Re: **PETITION NO. 1487** – TRITEC Americas, LLC petition for a declaratory ruling, pursuant to Connecticut General Statutes §4-176 and §16-50k, for the proposed construction, maintenance and operation of a 1.97-megawatt AC solar photovoltaic electric generating facility located at 254 Putnam Road, Pomfret, Connecticut, and associated electrical interconnection.

**Petition No. 1487  
TRITEC Americas, LLC  
Pomfret, Connecticut**

**Interrogatories – Set 2**

**G-100**

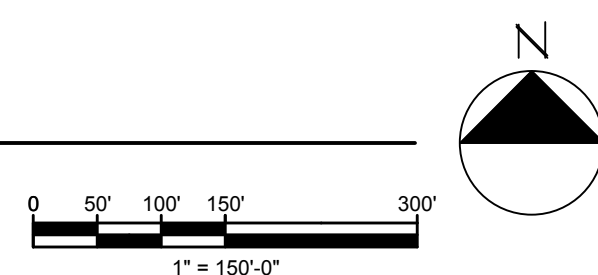
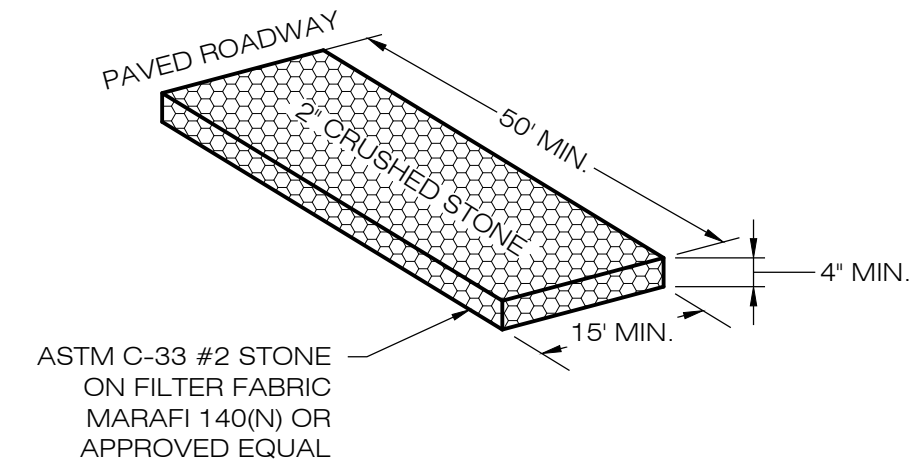
47. Interrogatory response 21 and the revised Decommissioning Plan states there will be 18 new utility poles instead of 12 as initially shown on the site plans. Revise the site plans to clearly show the location of all 18 utility poles.

48. How many utility poles does Eversource require? What is the purpose of each pole owned by Eversource? If equipment is installed on each pole, can this equipment be consolidated onto fewer poles? Explain.

49. How many utility poles does TRITEC require? What is the purpose of each pole? If equipment is installed on each pole, can this equipment be consolidated onto fewer poles? Explain.

51. The number of proposed panels in the Petition narrative and on the attached site plans do not match. Clarify.

**The site plan has been revised to show 18 utility poles. Please see attached, “Exhibit A: Site Plan.”**

**The project consists of 8 separate systems, and Eversource requires each system has its own separate overhead interconnection service. The Property Owner has reviewed and accepted the plan.**

**We believe Eversource will require ten poles; confirmation from Eversource is pending whether the equipment can be consolidated onto fewer poles. We will file a supplemental response immediately after we receive an answer.**

- Pole-1 (1) Utility disconnect switch, Pole mounted gang operated, utility lockable, 24/7 accessible, ground-able, visible break, shared by PV systems 1-8**
- P-2 (1) Utility recloser, pole-mounted, shared by PV systems 1-8**
- P-3 to P-10 (8) Bidirectional utility revenue meters for PV systems 1-8**

**TRITEC will require eight (8) additional poles.**

**P-11 to P-18 (8) OH circuit collection poles and customer disconnect switches for PV systems 1-8 as required to interconnect with the utility.**

**Due to utility safety concerns, the equipment cannot be consolidated on fewer poles.**

**Total Number of Panels: 4970 each – Trina TSM-DEG19C.20-540W**

**3 SILT FENCE WING DETAIL**  
SCALE: N.T.S.

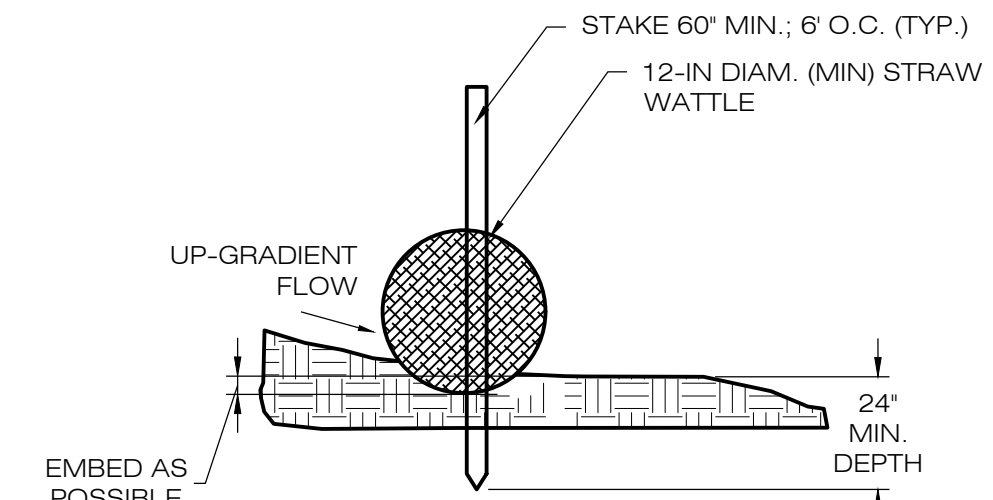
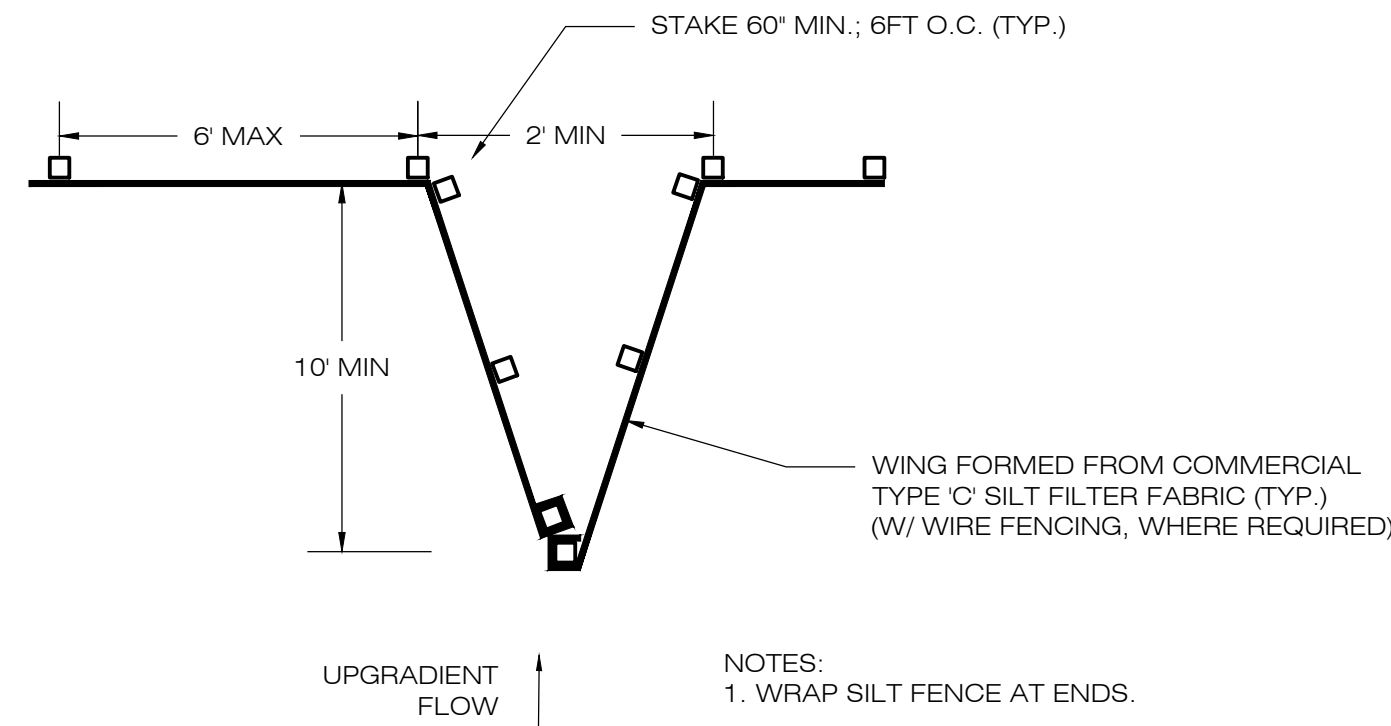
54. Does construction of the project require temporary sediment traps given that the amount of disturbance is 14.2 acres? If yes, revise the site plans to show locations. If no, explain why they are not necessary.

**The project does not require any temporary sediment traps. As referenced in response to Council Interrogatory 29, the perimeter silt fence will be equipped with “wings” (See “Exhibit B: Sedimentation & Erosion Control Details”). These limit the tributary array area from draining towards each section to 1-acre or less. The drainage swales designed with rock-check dams also mitigate potential sediment transport. DEEP has approved the proposed strategy on similar projects where there is no proposed tree clearing or mass grading.**
